WORKSHOP AGENDA

Planning Commission

August 15, 2023 @ 5:30 PM

Planning Commission Report Meeting: August 15, 2023	City of La Vergne

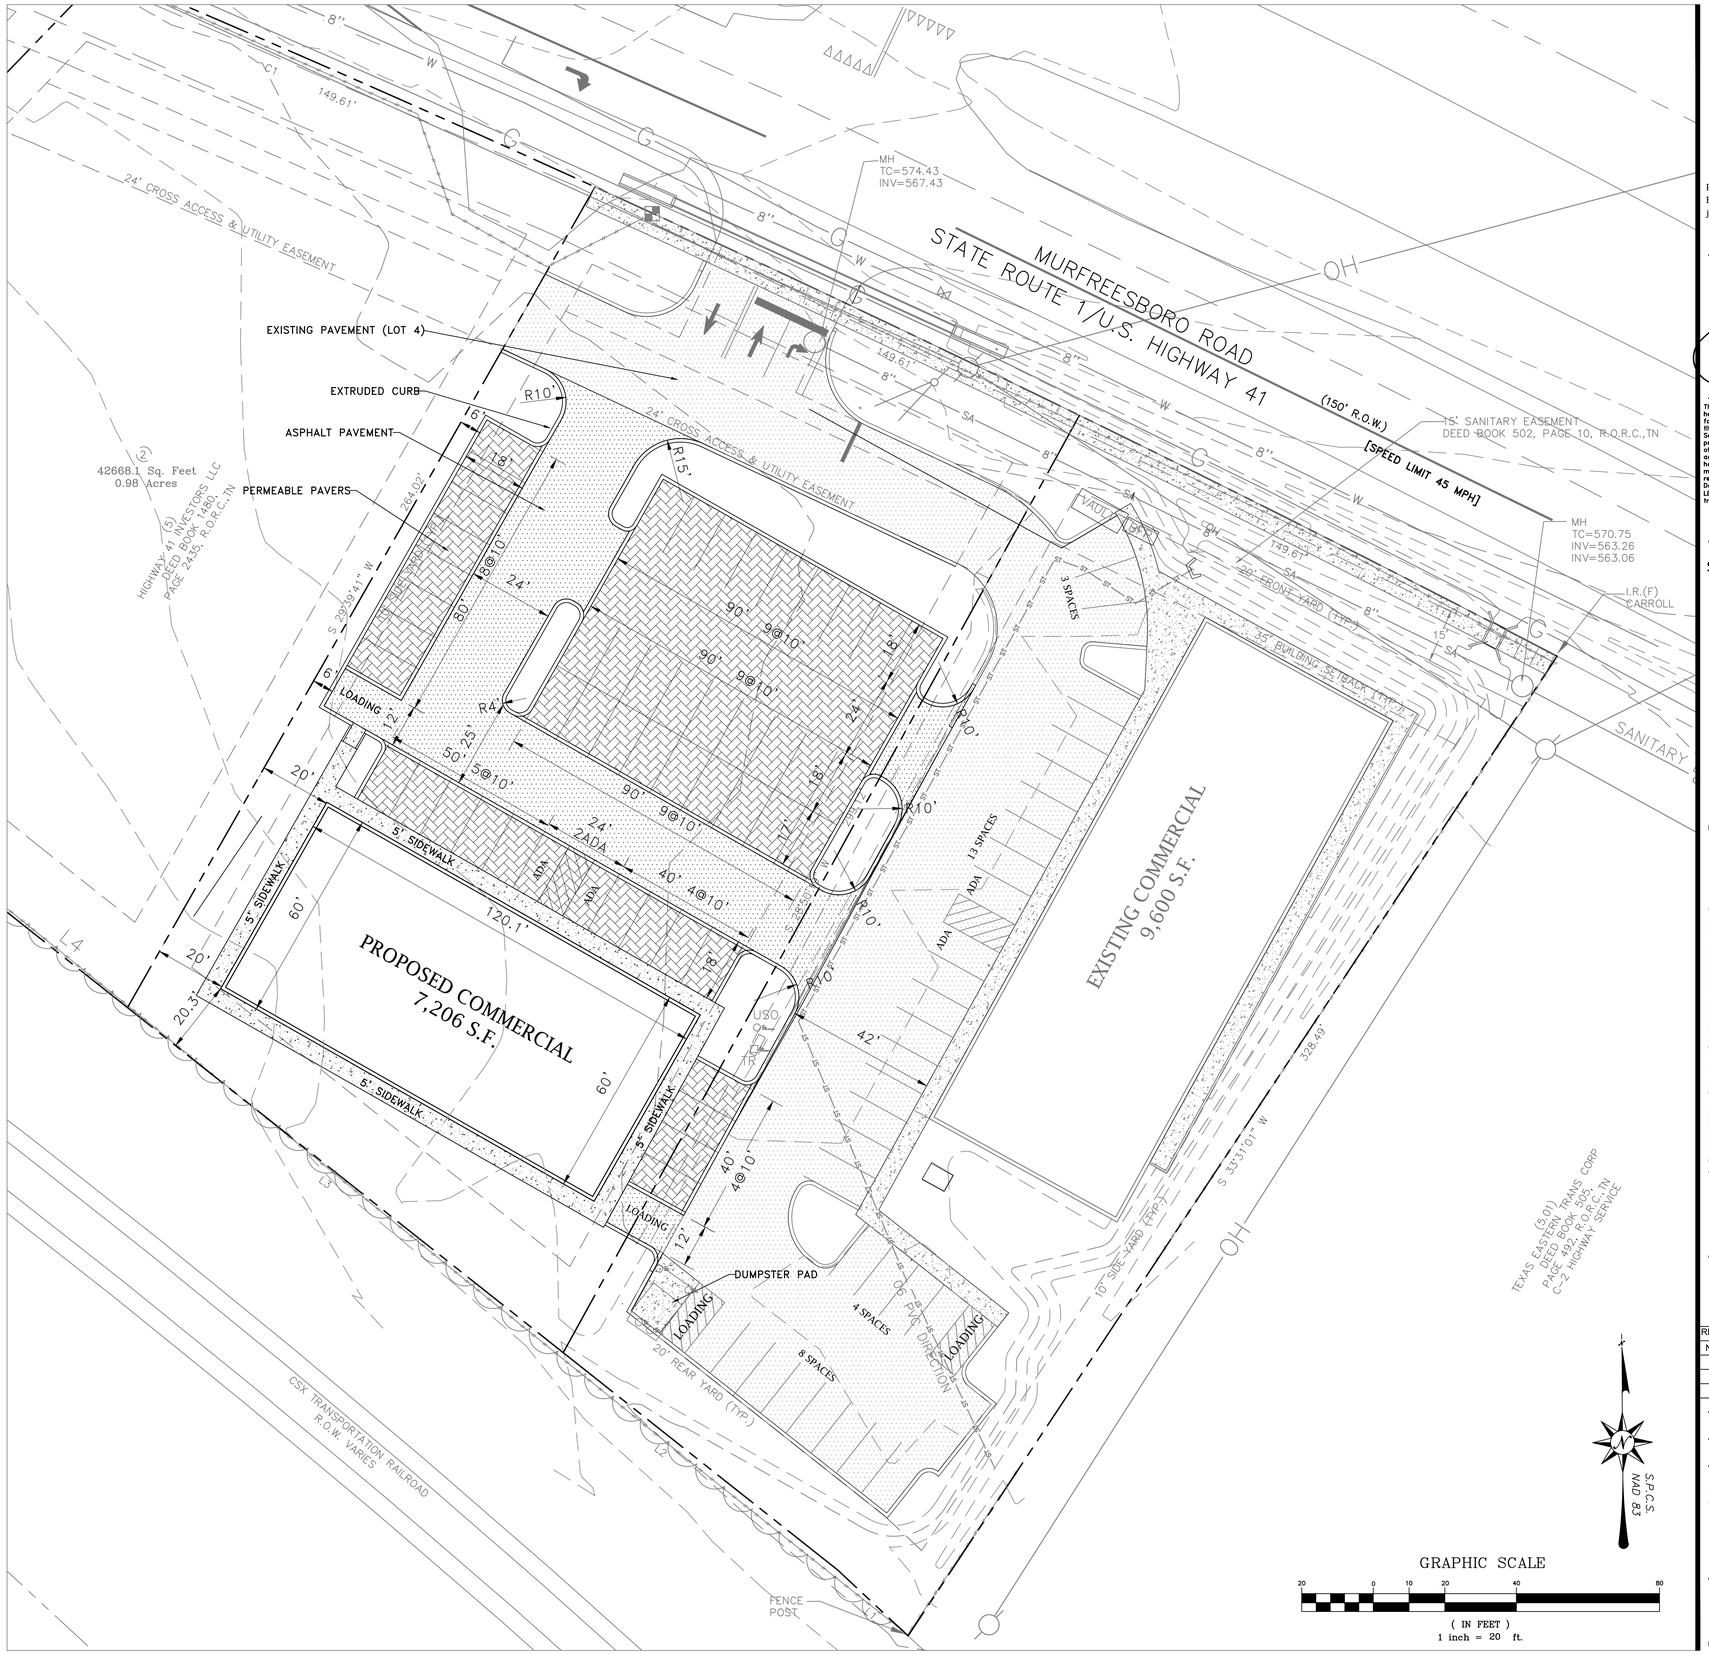
1. (C2.1) Provide sections of different pavement types. Make sure and provide manufacturer's information on pervious pavers.
2. (C4.1) Provide sections/details of underdrains

3. (C4.1) Confirm that roof drains completely to the front and into the water quality unit as stated in the calculations
4. (C2.1) Show width of driveway

5. (C2.1) Show distance from edge of driveway to west property line (shared with Washtopia)
6. (C2.1) Provide detail of commercial driveway ramp completion meeting TDOT standards

14. (C2.1) Show completion of connection to the Washtopia driveway ramp at west property line to complete the required cross access.
15. (C2.1) Call out the portion of the frontage sidewalk which is not existing and provide details and sections for its construction.

17. (C2.1) Confirm that the dumpster associated with the existing building will serve both buildings.
18. (C4.1) Outfall in northeast corner of Lot 4 does not have riprap and is beginning to erode. Please show
